ISSUE: Certificate of Appropriateness for signage

APPLICANT: Jesse Amador

621 King Street

STAFF RECOMMENDATION

SIMULATED NIGHT VIEW

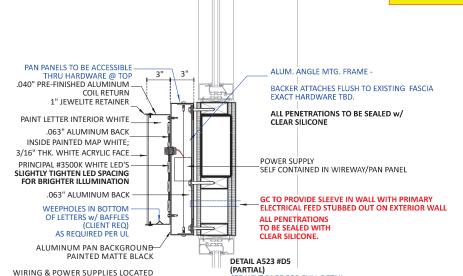
Staff recommends approval of the Certificate of Appropriateness for signage with the following conditions:

- 1. Use small targeted external illumination, such as mini spotlights or halo illumination for signs A and C. If halo lights are installed, the illumination shall be no greater than 150 lumens and the color of the light should be warmer rather than whiter/cooler and no greater than 3000K; and.
- 2. The blade sign (sign B) should be illuminated by mini spotlights.
